ELECTRICAL SAFETY INSPECTION REPORT

BIG BOSS CORPORATION LTD., MIDDLE BADDA, GULSHAN,
DHAKA-1212, BANGLADESH

Inspected on November 09, 2013

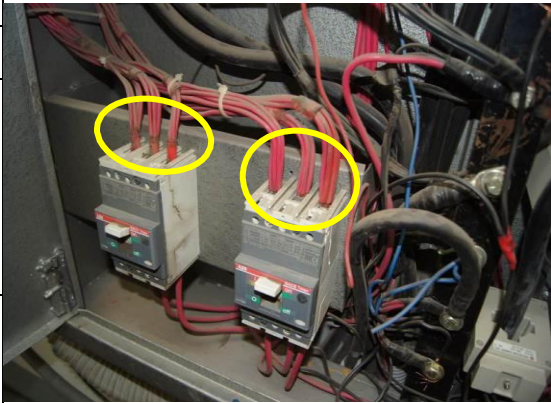
Finding #: E- 1	
Category: GENERATOR ROOM	
Finding: Cable termination at the generator control panel is laid on the floor covered in flexible PVC conduit and not fixed with cable lugs.	
Recommendation: Cable must be laid and supported on cable trays and raisers and must be fixed firmly with cable glands through gland plate	
Remediation Timeframe: 3 Months	Wiring and cable installation inside generator room

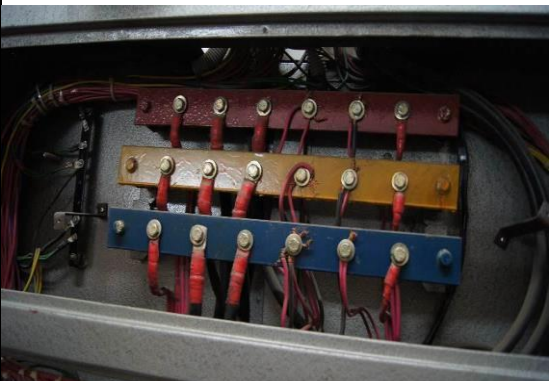
Finding #: E- 2	
Category: TRANSFORMER ROOM	
Finding: Cables and wires inside panels are not dressed.	
Recommendation: Cables terminating to & from panel must be dressed to avoid short circuit in side panel and to ease maintenance.	
Remediation Timeframe: 3 Months	Wiring inside LT panel

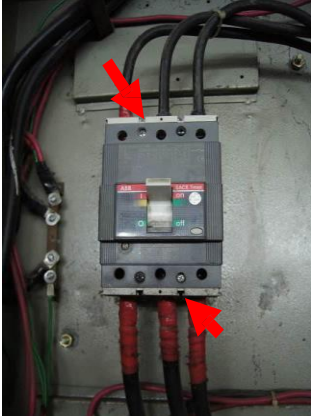
Finding #: E- 3	
Category: TRANSFORMER ROOM	
Finding: Cables/wires entering/leaving panels are not firmly fixed...	
Recommendation: Cables terminated to panel must be firmly fixed with cable glands through gland plate.	
Remediation Timeframe: 3 Months	Cables and wirings terminating at distribution panel (typical)

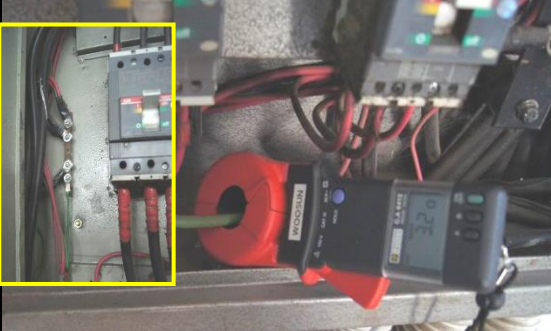
Finding #: E- 12	
Category: SWITCHBOARDS AND PANELS	
Finding: Cables/wires terminating at Motors/panels and devices are not fixed firmly.	
Recommendation: Cables terminating at motors, panels and devices must be terminated with proper cable gland. Cables/conduits must be supported on cable trays or raisers.	
Remediation Timeframe: 3 Months	Cables terminating at motor inside boiler room.
